Access Compliance Report

Public Rights-of-Way

(Curb Ramps)

Intersection ID: 45505	Main Street: GINHOUSE_LN	Cross Street: MEADOW_BOTTOM_RD	Location: SE
ADA ID: 2873C18E8F56	Ramp Type: PerpDiag	Initial Pass/Fail: Fail	Overall Compliance: No
Severity Score: 21.25			
Codes/Mitigation Info/Possible Solution		Field Measurements/Component Compliance

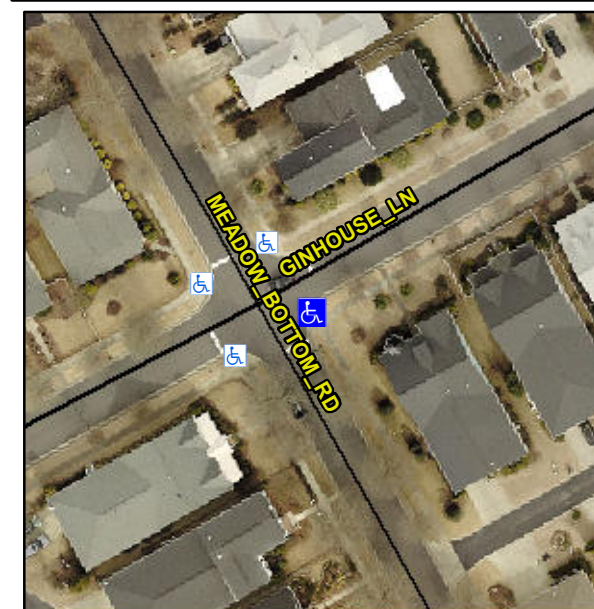
Not Found, R304.5.1, R304.2.2

Compliance	Description	Data	Compliance	Description	Data
N/A	Ramp Length (in)	71.0	No	Ramp Slope (%)	8.7
No	Ramp Width (in)	36.0	Yes	Ramp XSlope (%)	1.3
N/A	Flare Type LT	N/A	N/A	Flare Type RT	N/A
N/A	Flare Slope LT (%)	N/A	N/A	Flare Slope RT (%)	N/A
N/A	Flare Traversable LT?	N/A	N/A	Flare Traversable RT?	N/A
N/A	Landing Length (in)	N/A	N/A	DWS Provided?	N/A
N/A	Landing Width (in)	N/A	N/A	DWS Contrast?	N/A
N/A	Landing Slope (%)	N/A	N/A	DWS Length (in)	N/A
N/A	Landing X Slope (%)	N/A	N/A	DWS Full Width?	N/A
N/A	Landing Curb? (Y/N)	N/A	N/A	DWS Offset (in)	N/A
N/A	Shared Landing?	N/A			
N/A	Gutter Ponding?	N/A	N/A	Gutter Slope (%)	N/A
N/A	Gutter Lip Ht (in)	N/A	N/A	Gutter X Slope (%)	N/A
N/A	Painted X Walk1?	No	N/A	Painted X Walk2?	No
	X Walk 1 Direction	To NW		X Walk 2 Direction	To SW
N/A	X Walk 1 Width (in)	N/A	N/A	X Walk 2 Width (in)	N/A
	X Walk 1 Slope (%)	0.4		X Walk 2 Slope (%)	1.1
	X Walk 1 X Slope (%)	1.5		X Walk 2 X Slope (%)	0.0

Remove & Replace Curb Ramp With Two New Directional Ramps or Equivalent.
